TO ALL PLAN COMMISSION MEMBERS:

MEMORANDUM

SUBJECT: Willow River Bluffs First Addition: Preliminary Plat

SITE PLAN

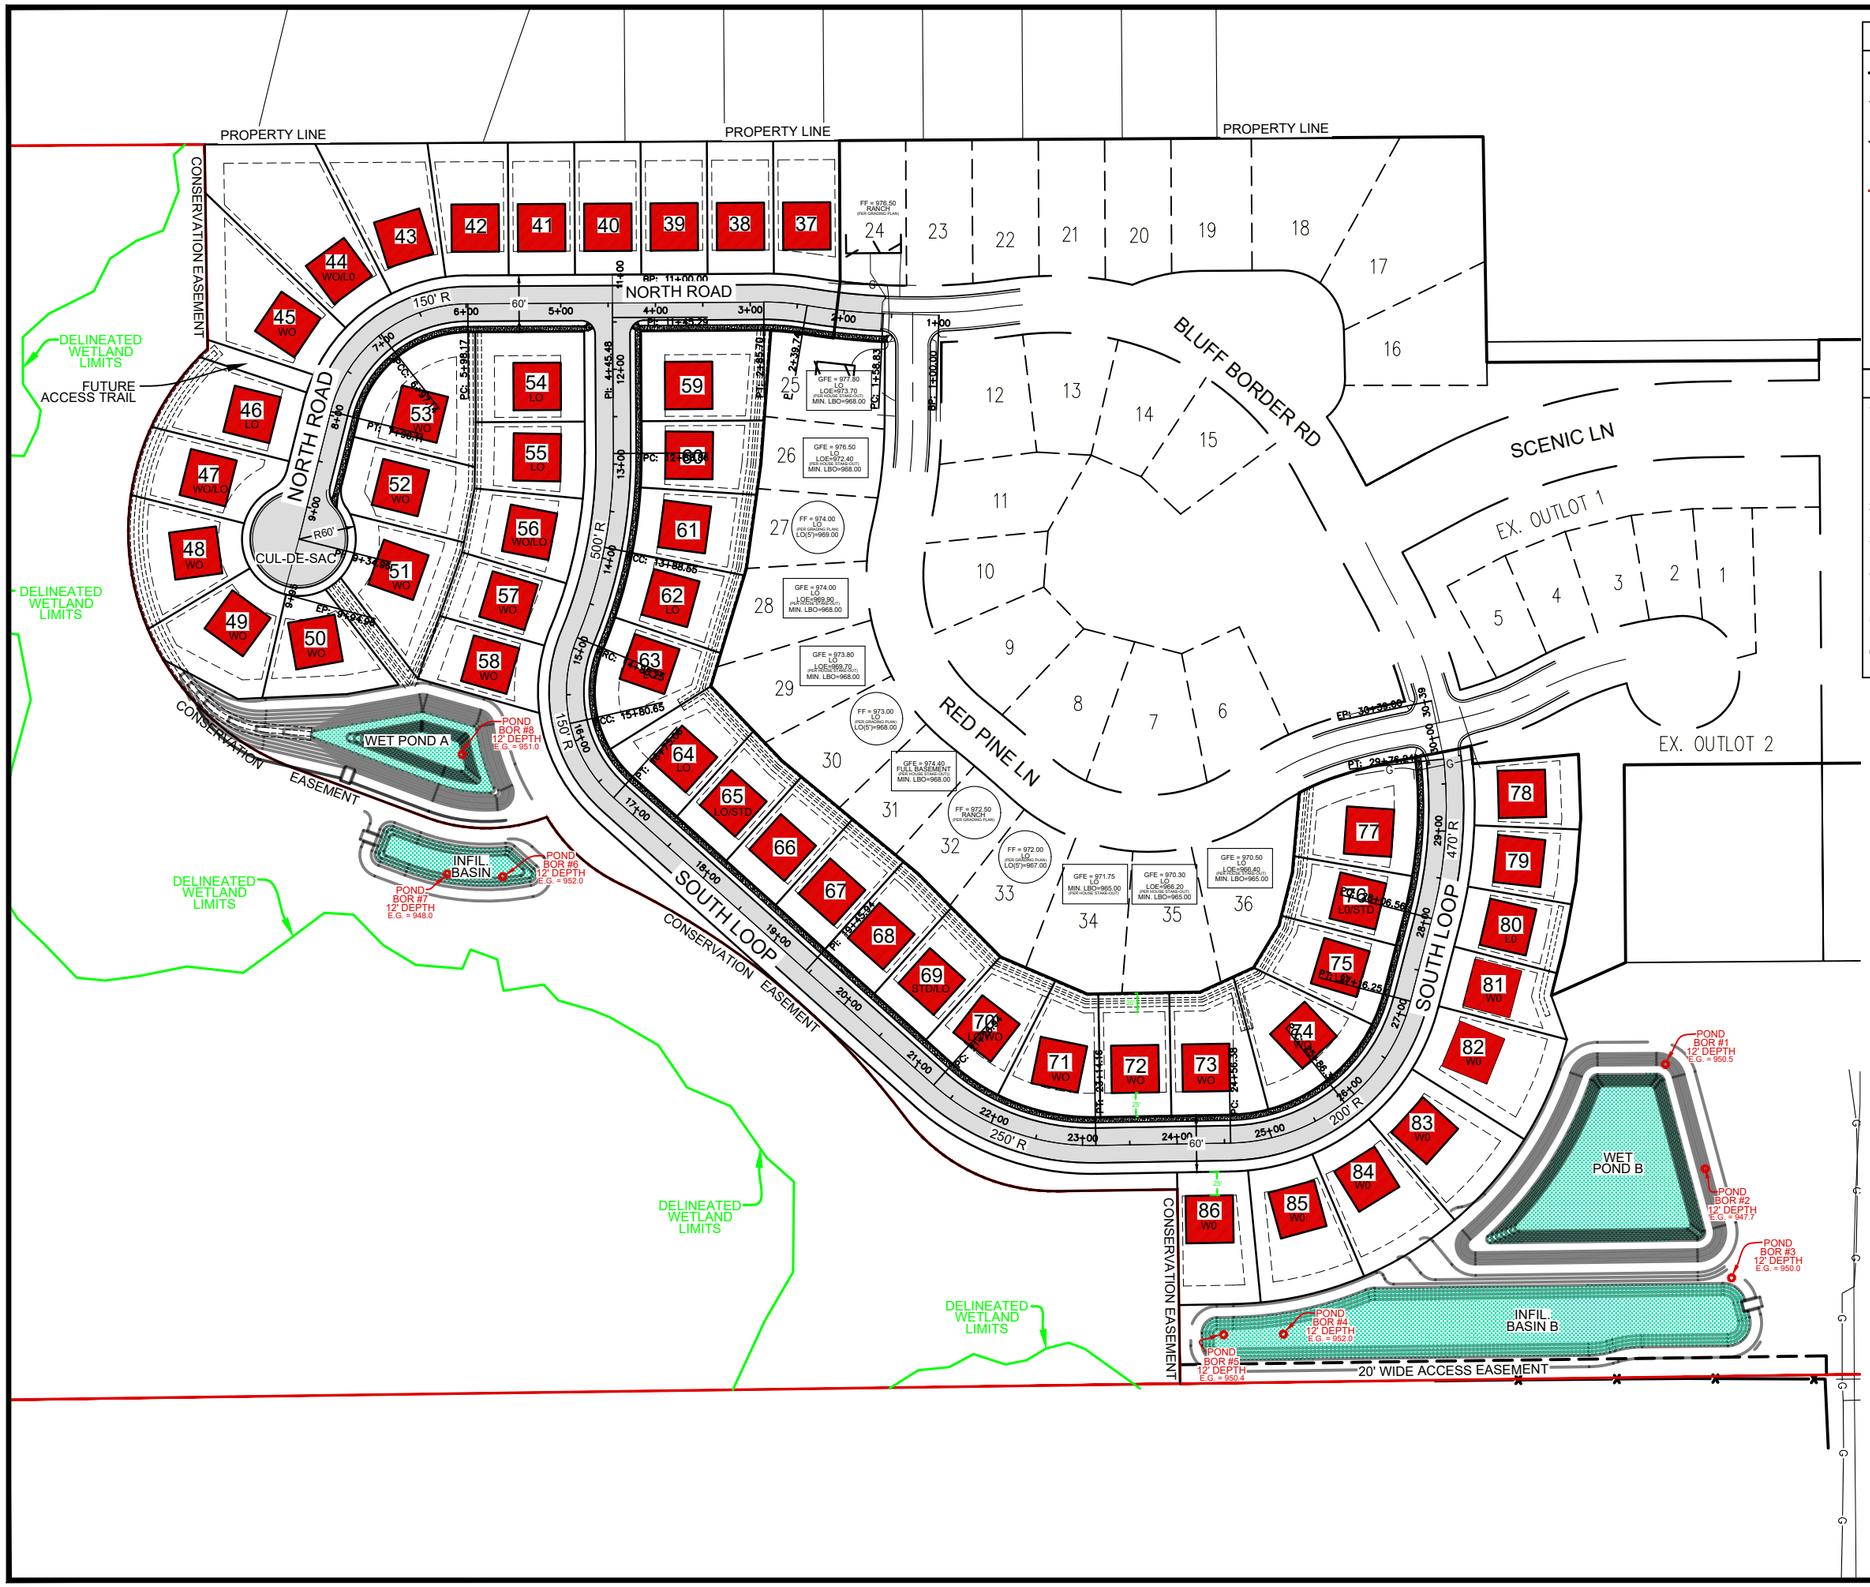
LOT OCCUPATION
Per the PUD requirements, the minimum lot width is 60 feet and the minimum lot coverage is 40 percent. This minimum lot width is less than the traditional 80 feet that would otherwise be required by the Zoning Ordinance for the Z2 Sub-Urban District. All of the lots shown comply with the minimum lot width requirement. Compliance with minimum lot coverage requirements would be verified prior to the issuance of a building permit in the future.

SETBACKS
Principal and accessory building setbacks within the PUD shall be as provided for within the Z2 Sub-Urban District, which are shown in the tables below. This is consistent with the information identified in the lot information table shown on the preliminary plat.

BICYCLE & PEDESTRIAN ACCOMMODATIONS
The site plan shows that a sidewalk will be provided along each street. The Development Review Committee recommends that a paved multi-use trail for emergency vehicle access be constructed from Conifer Court to Scenic Lane. This trail shall also connect to the boundary of the conservation easement near lot 86, where a future parking lot shall be constructed.

SHEET 1 OF 2 SHEETS

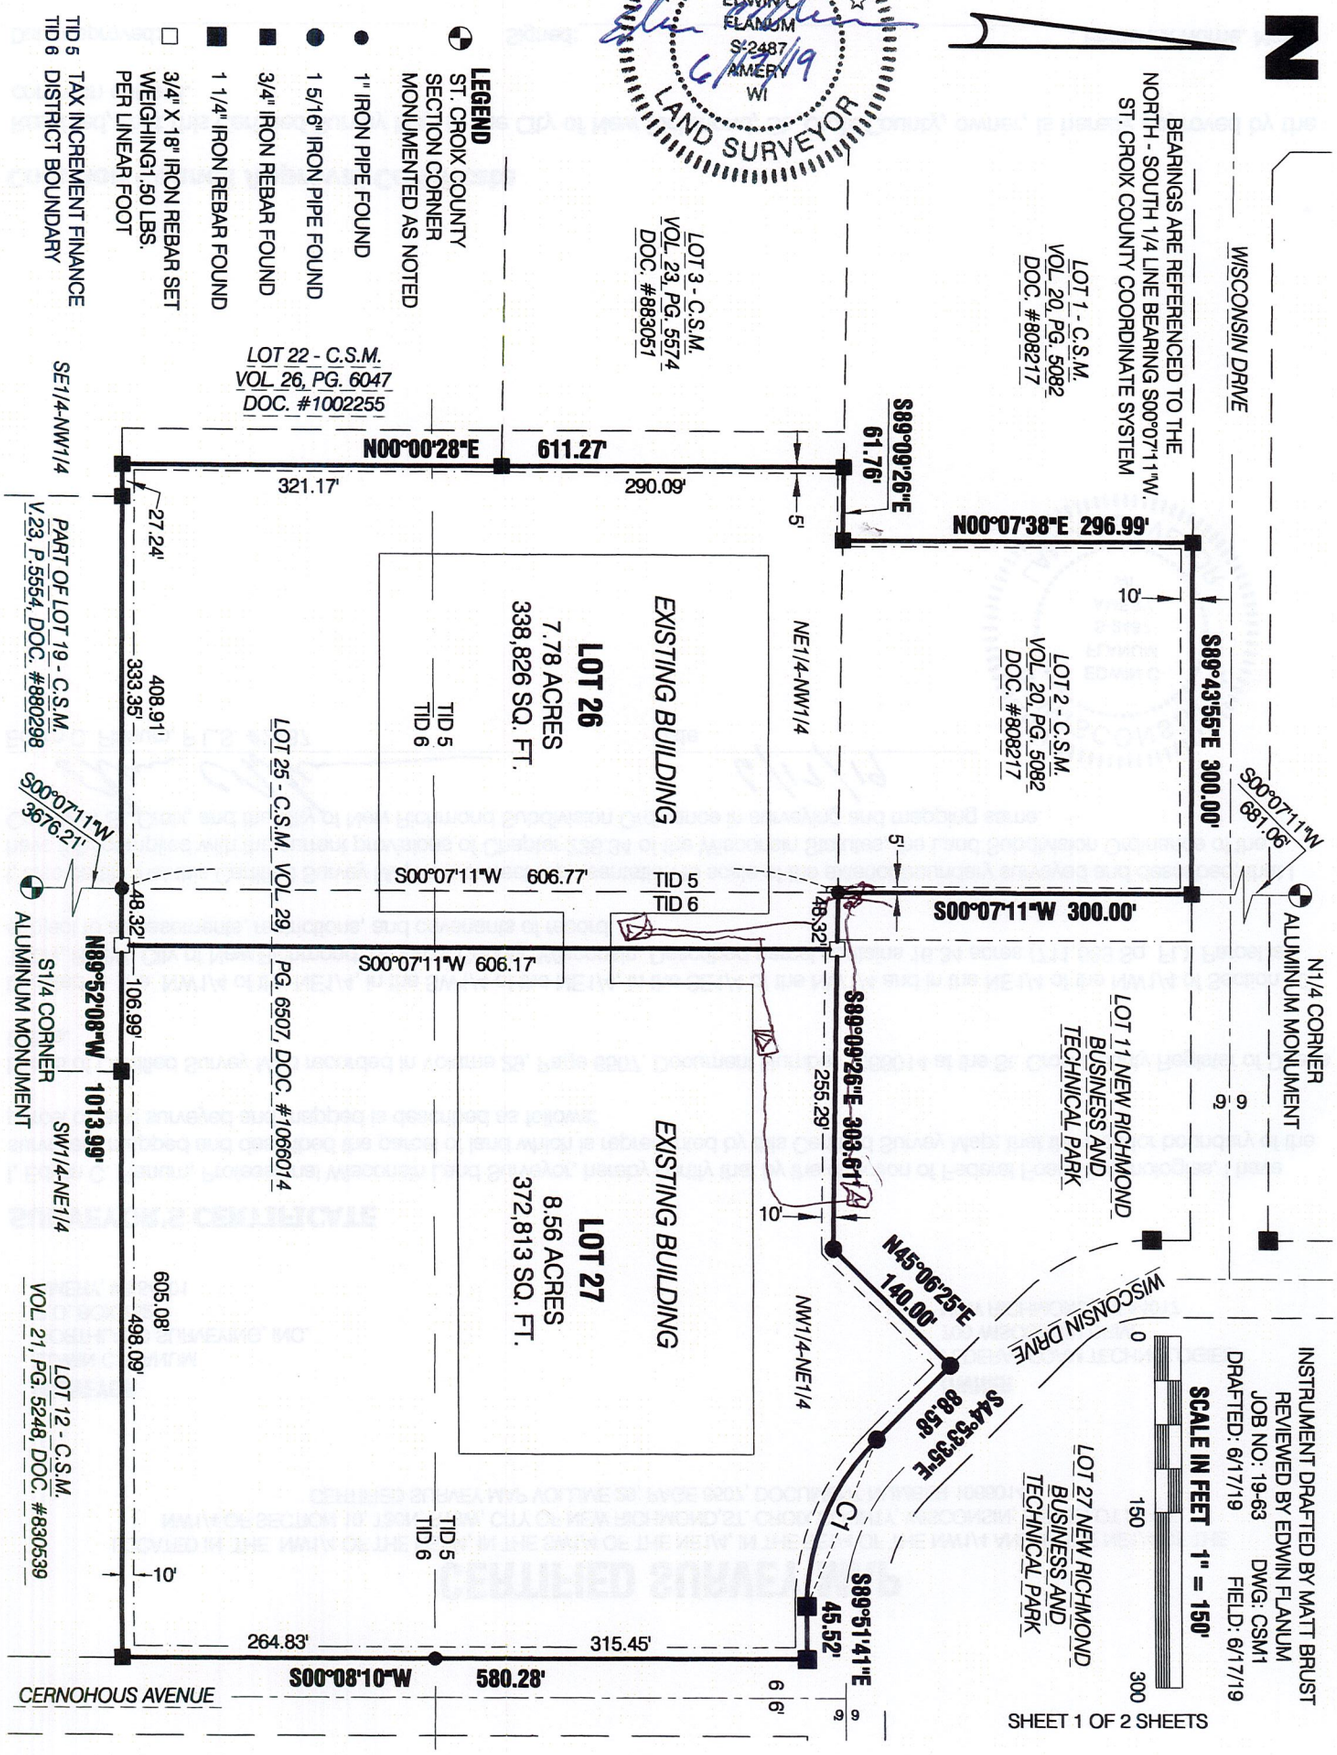
2. The CSM shall be revised to include an easement for drainage and utilities along the east property line of Lot 26 and the west property line of Lot 27, subject to review and approval by the Director of Public Works and Electric Superintendent.
